Possible Validation of Errors P1074 and P0476, Exhaust Butterfly Valve

Diavel V4 Model Year 2023 (all model versions)

Tips&Tricks Bulletin SRV-TTB-23-002

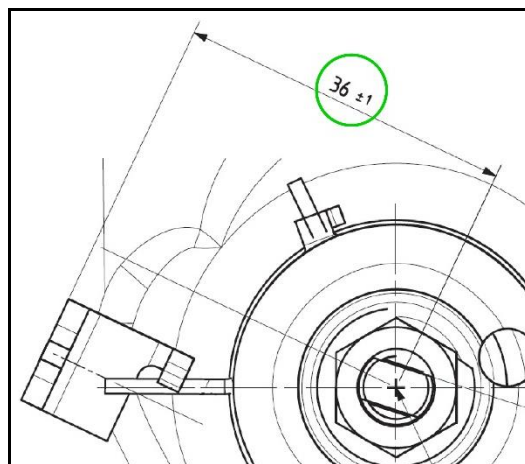
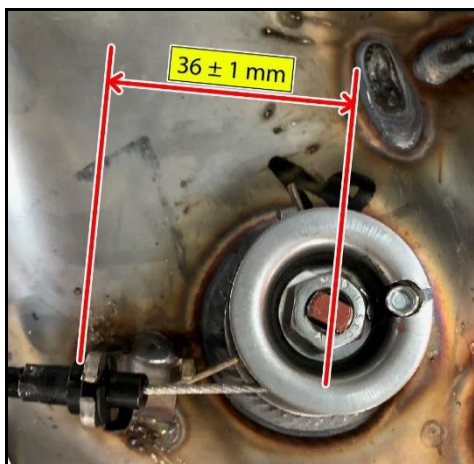
- Remove the left belly fairing cover and remove the exhaust butterfly valve motor without removing the Bowden cable. **Take a picture of the motor pulley to clearly show the position found at the time of the fault (see example below).**

Measure the distance between the center of the pulley and the Bowden cable support bracket. Check that it is **36 ± 1 mm (be careful as taking this measurement must be precise)**.

If this value is not correct, assess whether it is possible to slightly bend the bracket (normally in the direction of the pulley) to bring the gap back to the nominal value or whether it is necessary to replace the complete silencer.

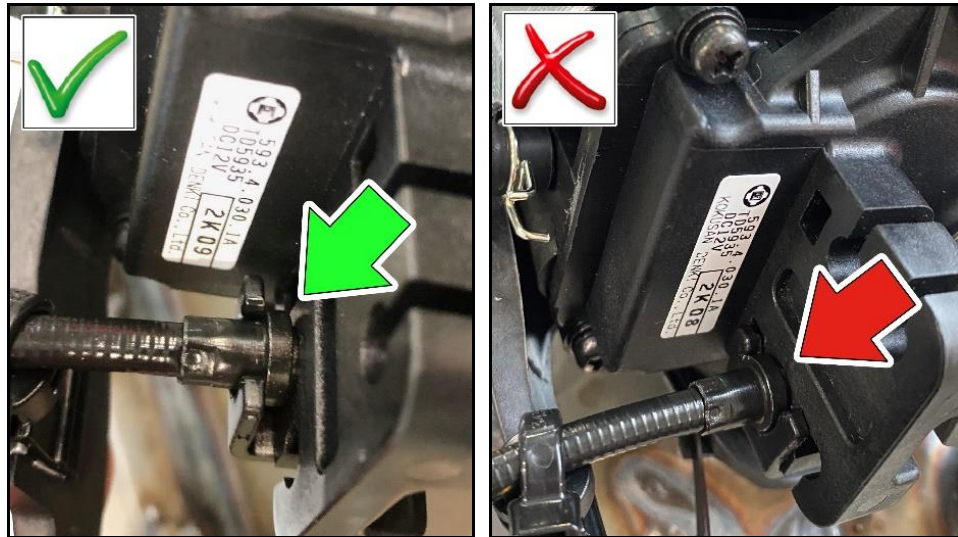
- In any case, during removal and upon refitting, make sure that the plastic clip preventing the sheath from falling out of the motor housing is present and in position, and that the ring nut with reduction at the end of the sheath is in place and correctly fitted.

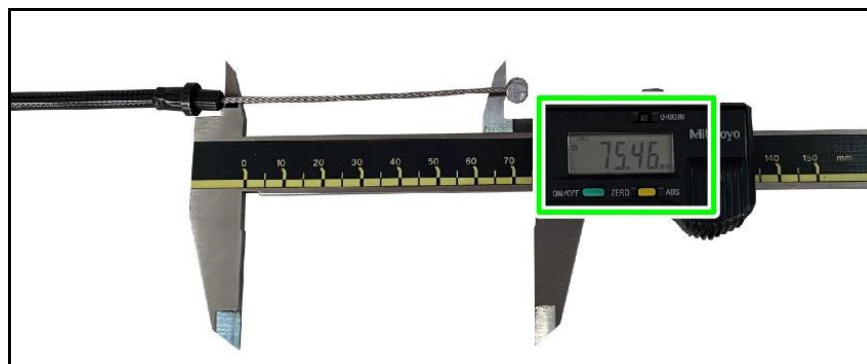
- Verify the Bowden cable is within tolerance. Measure from the end of the sheath to the cylinder retaining it to the pulley and/or valve and check that the length is 75.4 ± 1 mm.
